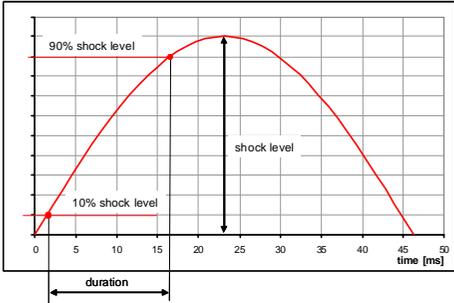
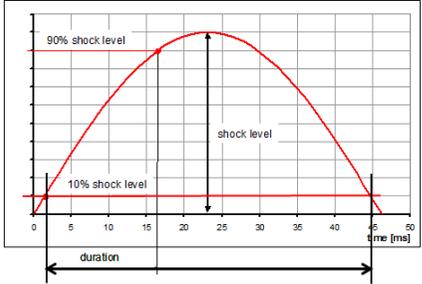
<p>Diagram 2-sinus shock pulse</p> 	<ul style="list-style-type: none"> • End duration point would be moved end of 10% shock level point not 90% shock level. 	<ul style="list-style-type: none"> ✓ Definition of duration time would be better harmonized to avoid confusion. (between ISO 16750)
<p>3.4.1.2.2 Acceptance criteria</p>		<p>For [RESS] using high voltage the isolation resistance measured at the end of the test shall maintain high voltage to ground isolation no less than 100 Ω/Volt.</p>		<ul style="list-style-type: none"> ✓ Measuring insulation resistance could not applied to module-based test. ✓ Only necessary for vehicle-based test.
<p>3.4.2 Mechanical integrity</p> <p>3.4.2.2.2 Acceptance criteria</p>		<p>For [RESS] using high voltage the isolation resistance measured at the end of the test shall maintain high voltage to ground isolation no less than 100 Ω/Volt.</p>		<ul style="list-style-type: none"> ✓ Measuring insulation resistance could not applied to module-based test. Only necessary for vehicle-based test.
